# SULLIVAN'S ISLAND STITH PARK – DRAINAGE IMPROVEMENTS

T&H PROJECT NO. J-32991

ADDENDUM NO. 3

April 8, 2026

Modify Detail on sheet C3.5  
Bid Addendum no. 3  
2026-04-08

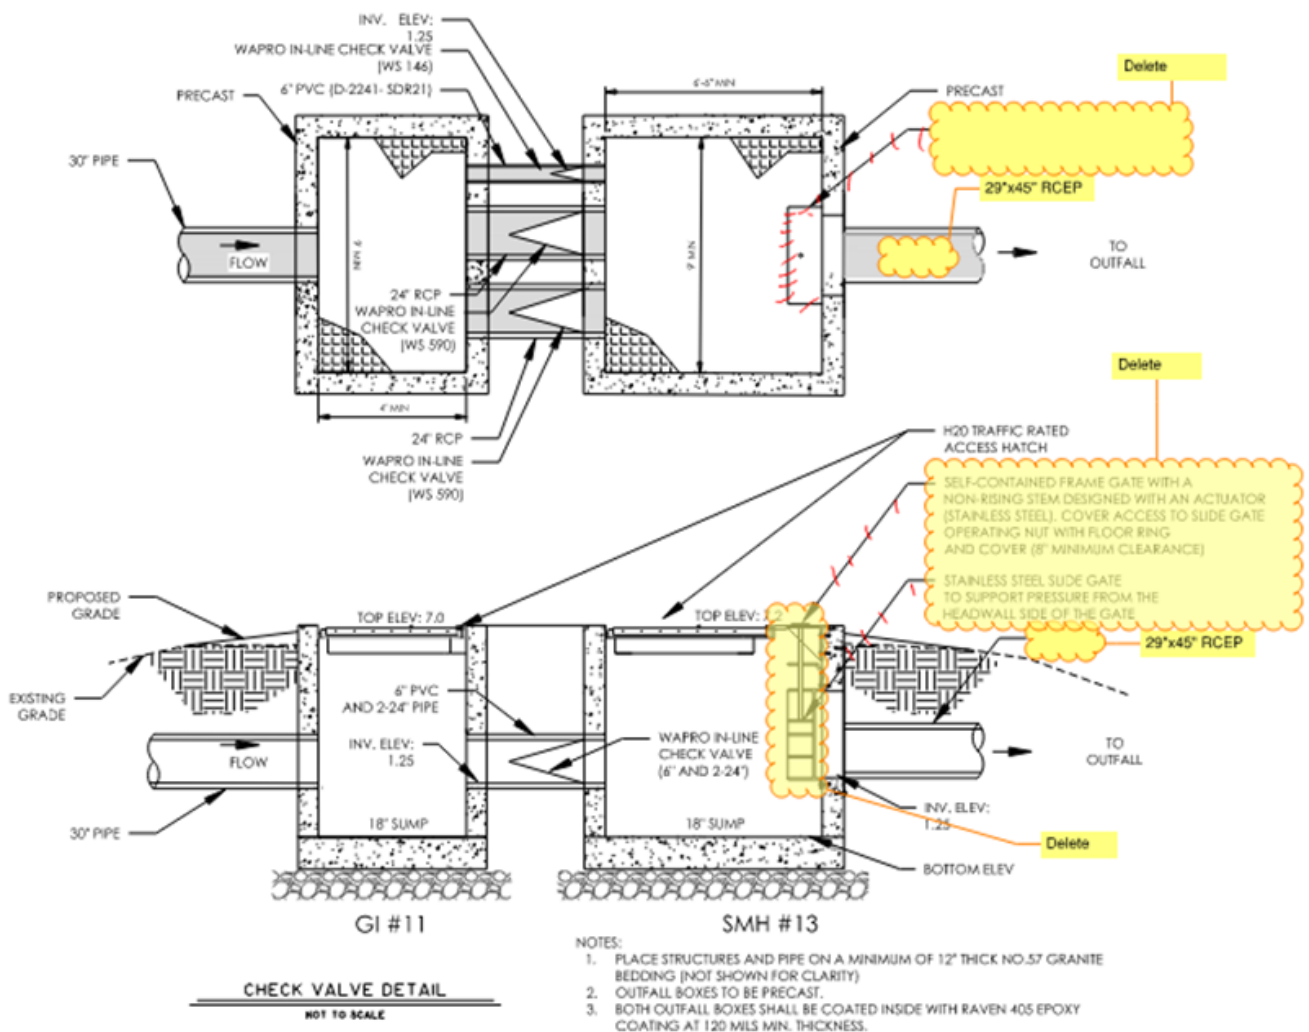
1. Modify "Check Valve Detail" on sheet C3.5 by deleting stainless steel gate in SMH#13. See red line markups on snapshot below.
